# MEADOW LAKE AIRPORT

# TRANSIENT APRON RECONSTRUCTION

AIP 3-08-0063-030-2026

JUNE 2026

SHEET  
C5.02

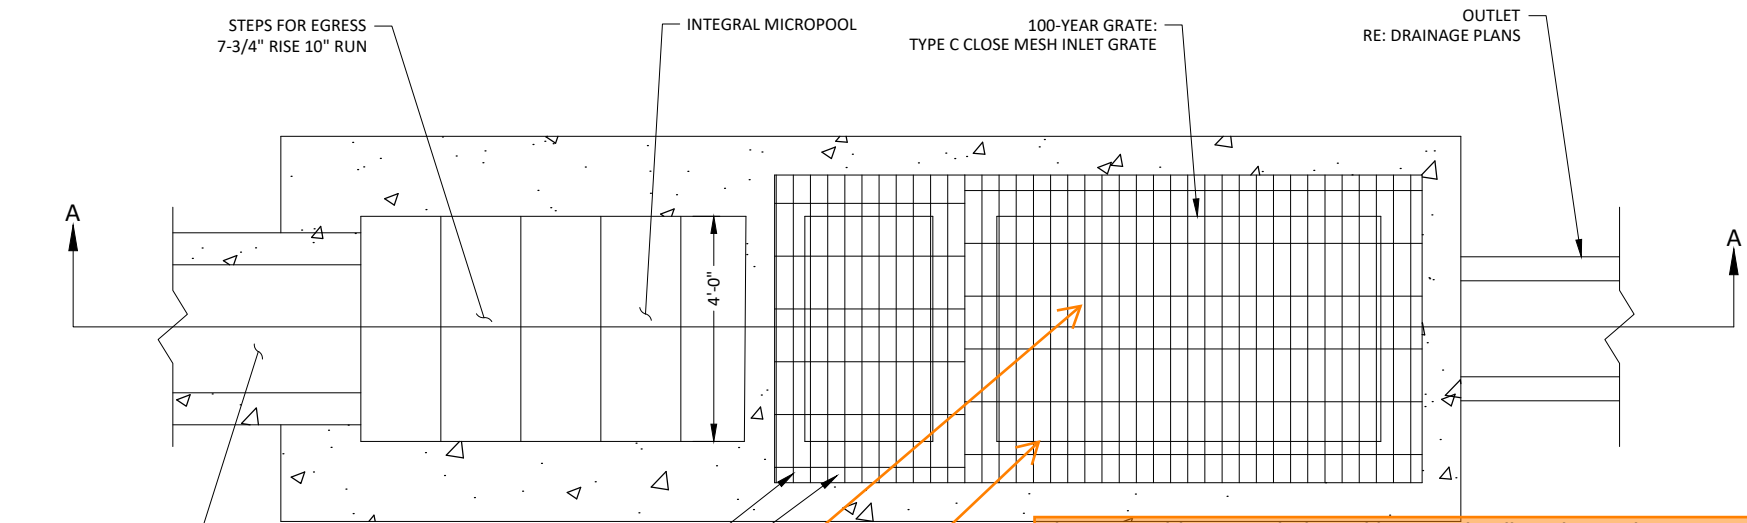
Show inside LxW dimensions of this area so I can compare to the calcs. The calcs show 4x4

show ladder steps for access/safety

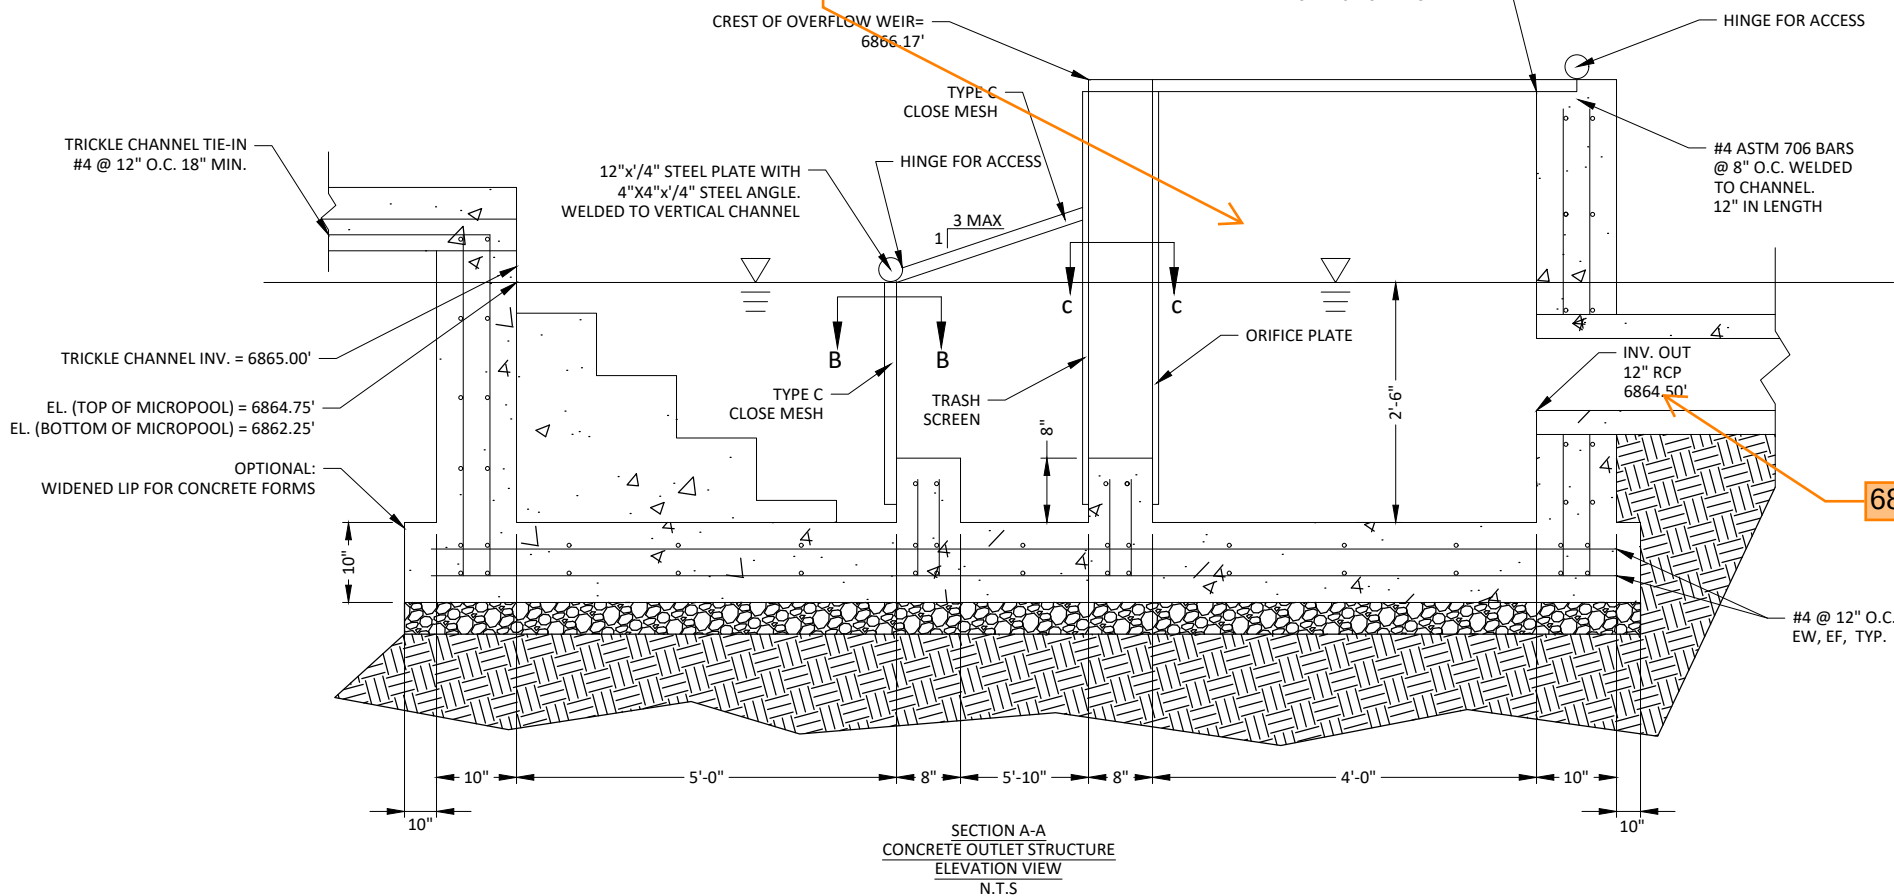
Please provide a note below with more detail on the gasket spec. Based on input gathered from industry experts, below is the recommended gasket spec:

The gasket shall be made of 1/4-inch thick, 60 durometer EPDM rubber in a continuous sheet the size of the orifice plate. The sheet shall be placed between the orifice plate and the concrete wall, with the width of the overlap between the plate and the concrete. Openings shall be cut into the sheet corresponding to the plate bolt holes and the concrete wall opening, cuts made either by the contractor in the field or by the manufacturer. Or equivalent gasket approved by EPC. Note that caulk is not an approved equivalent and will not be accepted by EPC.

6864.42 per calcs

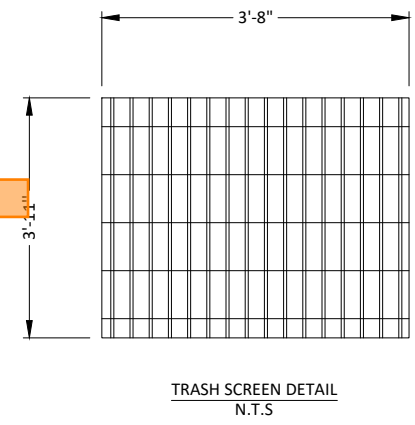
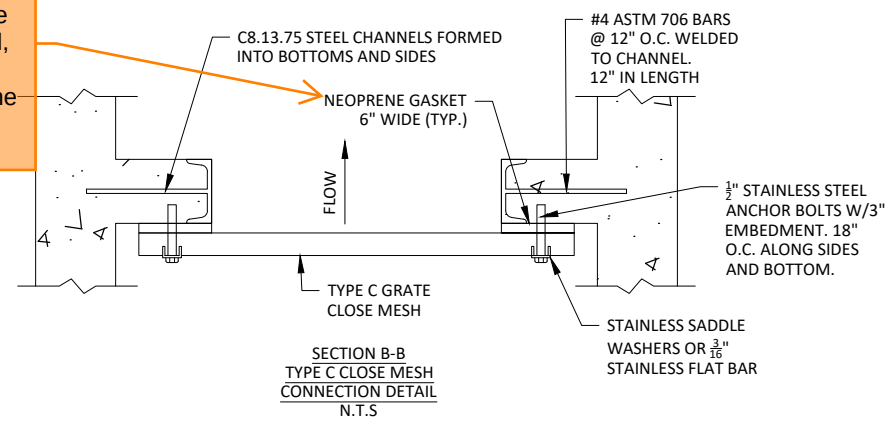
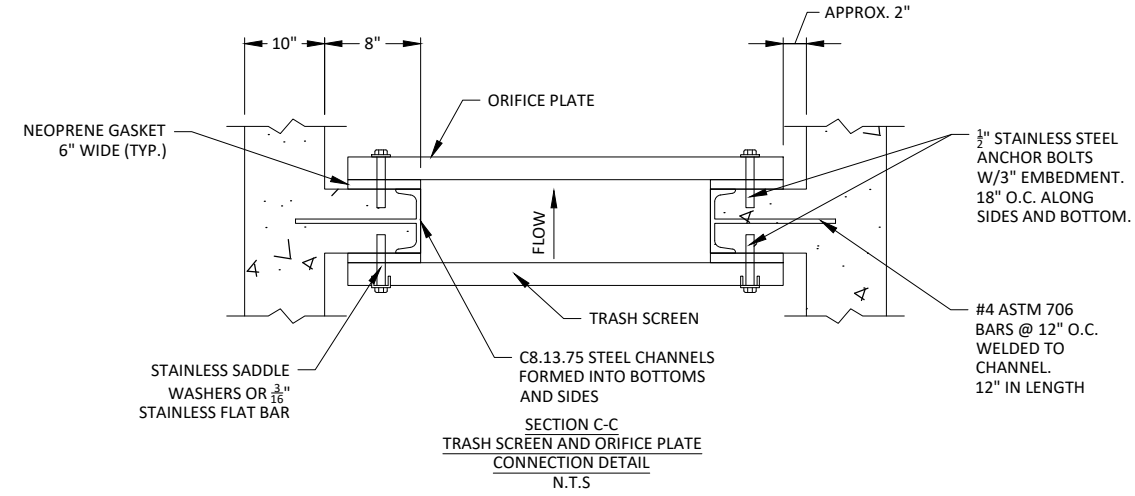
Add a note that this should be manufactured with exterior bars in the vertical orientation.

ORIFICE PLATE DETAIL  
N.T.S.

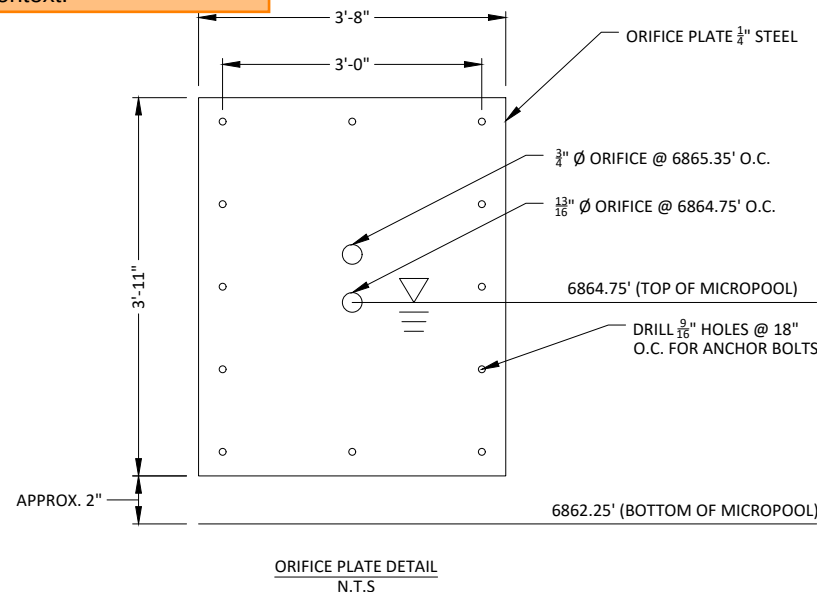
A trickle channel with this skinny of a width will only be maintainable via shovels. The small extra cost of concrete to make it wider and maintainable via small machinery will make it easier for long term maintenance. But discuss with your client on how they anticipate maintaining this. Sediment will likely need to be removed from the trickle channel at least 1-2 times per year for context.

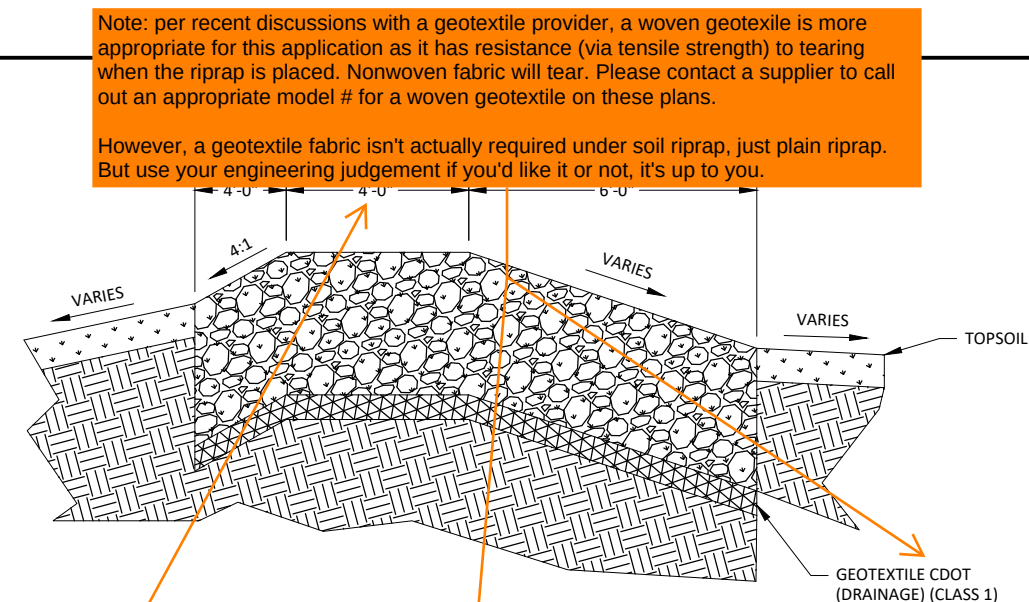
There is an input on the MHFD-Detention calcs for "Spillway Crest Length" which you inputted as 4 and is 4 on the detail above. It's counterintuitive by MHFD actually defines the Spillway Crest Length as: *"the bottom length of the spillway and is measured perpendicular to the flow direction."* So the 4ft dimension should actually be in the bottom detail here where you show 23'-6". So please make that revision.

Per our criteria (DCMv1 Chap 11.3.3) the min top of embankment width is 12ft. But that is not necessary for a pond this small, we would accept a 4ft width if you want to leave it as-is.

SPILLWAY  
END VIEW  
N.T.S.

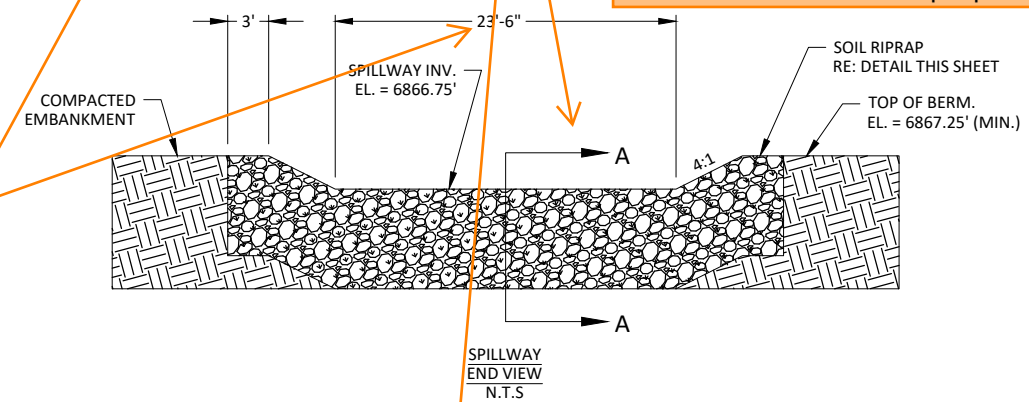
Note: per recent discussions with a geotextile provider, a woven geotextile is more appropriate for this application as it has resistance (via tensile strength) to tearing when the riprap is placed. Nonwoven fabric will tear. Please contact a supplier to call out an appropriate model # for a woven geotextile on these plans.

However, a geotextile fabric isn't actually required under soil riprap, just plain riprap. But use your engineering judgement if you'd like it or not, it's up to you.

See my comment on the MHFD-Det calcs in the FDR about showing Freeboard and Spillway Design Flow Depth. Make a note next to (or below) the freeboard callout that this was an approved deviation per talks with EPC. Just so it's documented in multiple places.

SOIL RIPRAP DETAIL  
N.T.S.

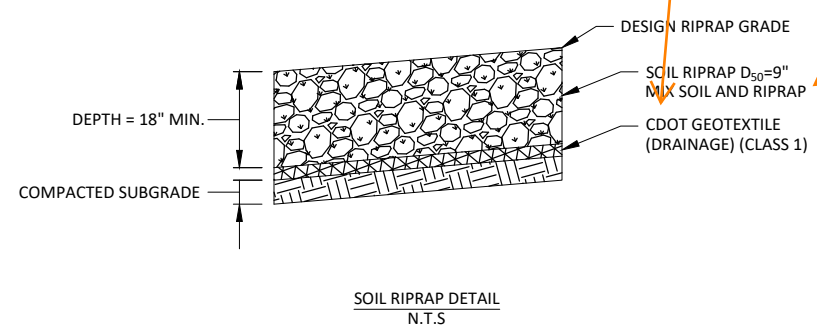
Specify installation instructions and mix ratio for soil riprap. As an example, note: "Per MHFD Spec Section 31-37-00, the soil material shall be native or topsoil and mixed with 65% riprap and 35% soil by volume. And soil riprap shall consist of uniform mixture of soil and riprap without voids."
